## IMPORTANT INFORMATION

**IMPORTANT:** Discard and replace bulletin dated 897

### 2.5 Cowl Trim Switch Installation

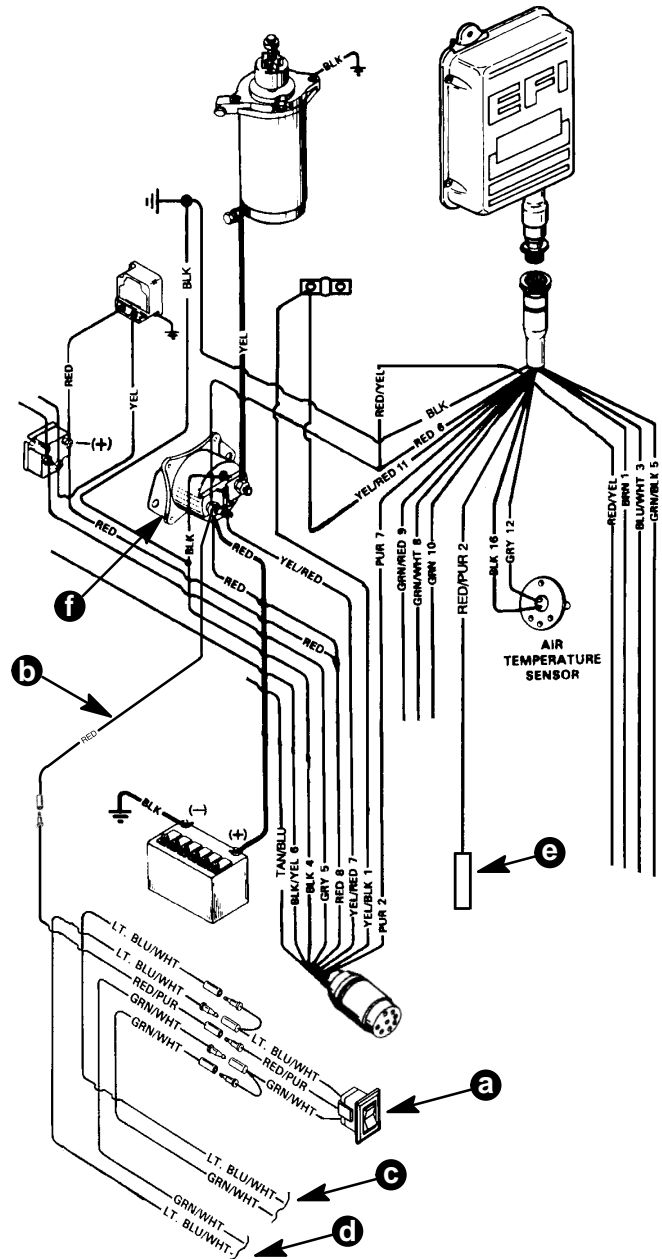
**PROBLEM: INCORRECT TRIM SWITCH WIRING CONNECTIONS**

When installing a cowl mounted trim switch, the possibility of connecting the wrong wires exists and extreme caution must be exercised when making connections. If connections are made incorrectly, severe damage to the operating systems of your outboard could occur.

**IMPORTANT:** The power source to operate the trim switch must come from the (+) red lead of the engine mounted solenoid. An existing Red/Purple wire (which is intended to be used for an electric fuel pump) extends from the EFI wiring harness connection on the engine. This lead **CAN NOT** be used as the power lead for the trim switch connection even though the color coding matches. If used, this connection may cause severe operating system damage to your outboard.

1. Connect the Red/Purple lead of the new Cowl Trim Switch to the Red lead terminal on the engine mounted solenoid.
